SUBJECT: Approved Defense Logistics Management System (DLMS) Change (ADC) 398, Revise DLMS 846A Asset Reclassification, 947I Inventory Adjustment, and Associated Procedures to Support Marine Corps BRAC Storage and Distribution Interface (Supply) (Staffed as PDC 421)

ATTACHMENT TO ADC 398

Revise DLMS 846A Asset Reclassification, 947I Inventory Adjustment, and Associated Procedures to Support Marine Corps BRAC Storage and Distribution Interface (Supply)

ENCLOSURE 1 TO ADC 398 Transaction Flow Diagram

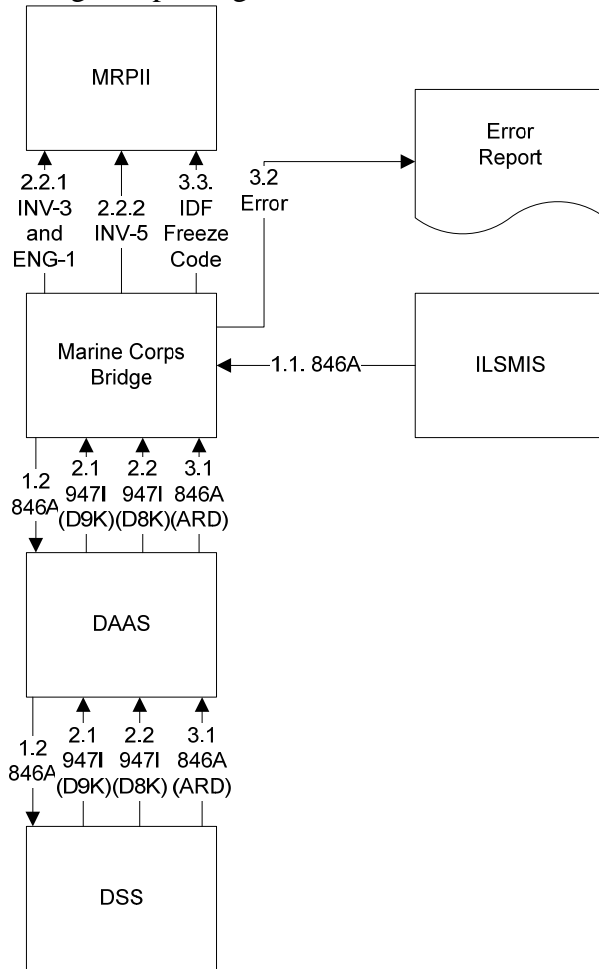
1. ILSMIS creates a unit of use record where unit of use is different than FLIS unit of issue (or existing LSN unit of issue)
 - 1.1. ILSMIS sends 846A transaction to Marine Corps bridge to identify new unit of use

- 1.2. Marine Corps bridge sends 846A transaction through DAAS to DSS to create or update unit of use
2. If no pending inventory affecting transactions, DSS creates or updates unit of use LSN

- 2.1. DSS sends 947I (D9K) for inventory loss through DAAS to Marine Corps bridge (DSS will return original document number from 846A on transaction)

- 2.2. DSS sends 947I (D8K) for inventory gain through DAAS to Marine Corps bridge (DSS will return original document number from 846A on transaction)

- 2.2.1. Marine Corps bridge sends INV-3 and ENG1 to MRPII to update item master record in MRPII
 - 2.2.2. Marine Corps bridge sends INV-5 to MRPII to update on hand quantity

- 2.2.3. Marine Corps bridge will remove the IDF freeze code if necessary
3. If pending inventory transactions against NSN, DSS will reject the request

- 3.1. DSS sends asset reclassification denial 846A (ARD) through DAAS to Marine Corps bridge to identify reason for denial
- 3.2. Marine Corps bridge will generate error report and email
- 3.3. Marine Corps bridge will set freeze indicator in MRPII until error is cleared from log/report
 - 3.3.1. Marine Corps will contact warehouse to validate error is cleared
 - 3.3.2. Start over at 1.1 (Marine Corps needs to develop a form to indicate resubmission of 846A required)
4. C4 create Unit of Use (846A Resend) screen to allow MC Analyst to resubmit 846As after DSS transactions have cleared.
